NOTICE OF PROPOSED CHANGE IN PROPERTY

Petition: x580

REQUEST BERM USE
 (For Parking Only)
 INTO E. EIGHT MILE RD.
 AT 12444 E. EIGHT MILE RD.

CITY OF DETROIT CITY ENGINEERING DEPARTMENT	
SURVEY BUREAU	
JOB NO.	01-01
DRWG. NO.	X 580

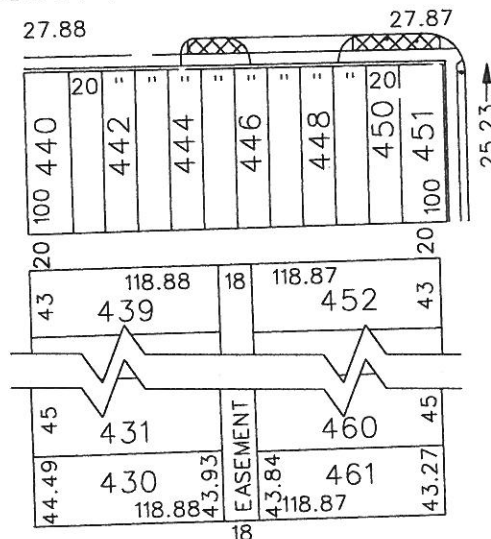
PLA objects the proposed Berm use for parking
Allowing parking in Berm area will put the light
poles at risk of being hit. The poles can not be relocated.

Note: This is ^aMDOT Row..
